U.S. Department of the Interior BUREAU OF LAND MANAGEMENT Sundry Print Repor

Well Name: AVALON FEDERAL Well Location: T17S / R30E / SEC 6 / County or Parish/State: EDDY /

Sundry ID: 2655851

Type of Submission: Notice of Intent Type of Action: Plug and Abandonment

<u>Lease & Well #</u> Avalon Federal #1
<u>API:</u> 30-015-35950

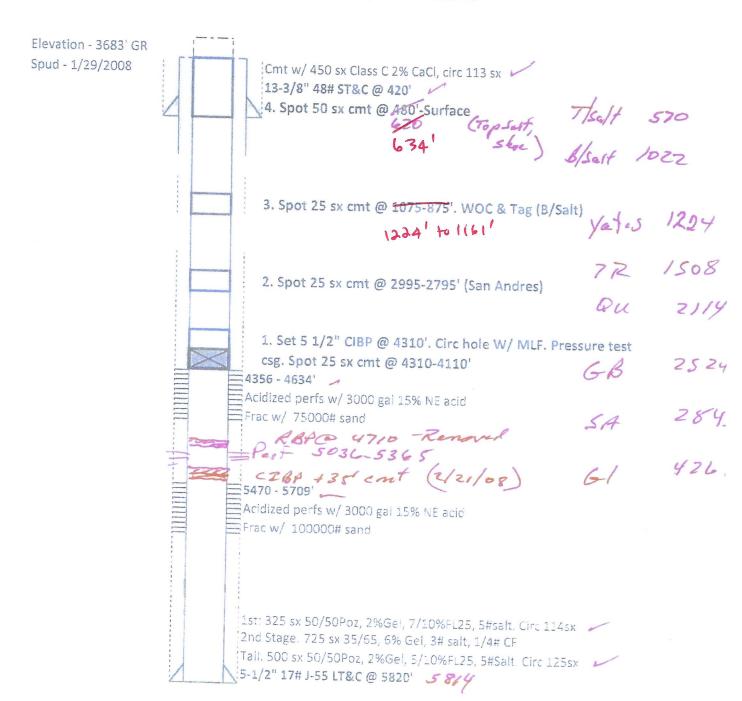
Cultury 15	2000001	1		1	·	
			for dispersional participation of the control of th			
Plug Type	Тор	Bottom	Length	Tag	Sacks	Notes
Surface Plug	0.00	100.00	100.00	Tag/Verify		
Top of Salt @ 322	268.78	372.00		Tag/Verify		
Shoe Plug	365.80	470.00		Tag/Verify		
						Perf at 634'. Spot
						from 634' to
Base of Salt @ 584	528.16	634.00	105.84	Tag/Verify	65.00	Surface. Verify at
				If solid		
				base no		
				need to		
				Tag		And the second s
				(CIBP		vide and de la constant de la consta
				present

16.2		and/or		
				Mechanic		
				al Integrity		
				Test), If		
				Perf &		
				Sqz then		
				Tag, Leak		
				Test all		
				CIBP if no		
Yates @ 1224	4404.70	4074.00		Open		Spot from 1224' to
Glorieta @ 4268	1161.76 4175.32	1274.00		Perforatio	25.00	1161'.
	4170.32	4318.00	142.68	If solid		
				base no		
			1	need to		
			1	Tag		
				(CIBP		
			1	present

- 1	and/or		
			1	Mechanic		
			1	al Integrity		
				Test), If		
				Perf &		
				Sqz then		
				Tag, Leak		Set CIBP at 4310'.
				Test all		Spot from 4310' to
				CIBP if no		4175'. WOC and
				Open		Tag. Leak Test
CIBP Plug	4275.00	4310.00		Perforatio	25.00	
Perforations Plug (If No CIBP)	4306.00	5759.00		Tag/Verify		Not Necessary
Shoe Plug	5711.80	5870.00		Tag/Verify		Not Necessary

Cave Karst/Potash Cement	Low		
Shoe @	420.00		
Shoe @	5820.00		
Perforatons Top @	4356.00	Perforations	5709.00
	1000.00	renorations	3709.00
		CIBP @	4310.00

<u>Lease & Well #</u> Avalon Federal #1

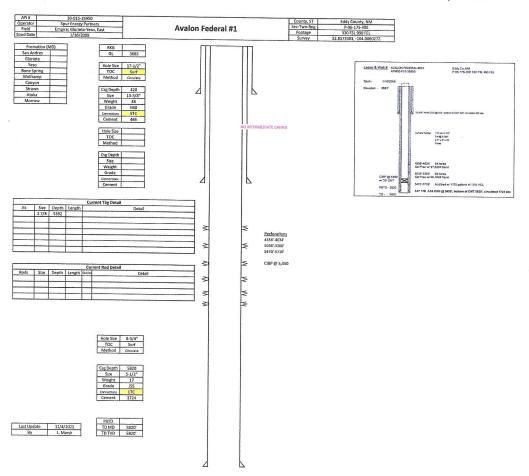
Elevation - 3683' GR Spud - 1/29/2008 Cmt w/ 450 sx Class C 2% CaCl, circ 113 sx 13-3/8" 48# ST&C @ 420' V 4. Spot 50 sx cmt @ 480'-Surface (Top Saft, Store) B/Saft 1022 3. Spot 25 sx cmt @ 1075-875'. WOC & Tag (B/Salt) Yates 1508 72 2. Spot 25 sx cmt @ 2995-2795' (San Andres) Qu 2114 1. Set 5 1/2" CIBP @ 4310'. Circ hole W/ MLF. Pressure test 2524 csg. Spot 25 sx cmt @ 4310-4110' GB 4356 - 4634' Acidized perfs w/ 3000 gal 15% NE acid Frac w/ 75000# sand RBPC 4710 - Renoved Perf 5036-5365 CZBA +35' ent (2/21/08) Acidized perfs w/ 3000 gal 15% NE acid Frac w/ 100000# sand 1st: 325 sx 50/50Poz, 2%Gel, 7/10%FL25, 5#salt. Circ 114sx 🛹 2nd Stage: 725 sx 35/65, 6% Gel, 3# salt, 1/4# CF Tail: 500 sx 50/50Poz, 2%Gel, 5/10%FL25, 5#Salt. Circ 125sx 5-1/2" 17# J-55 LT&C @ 5820' 5824
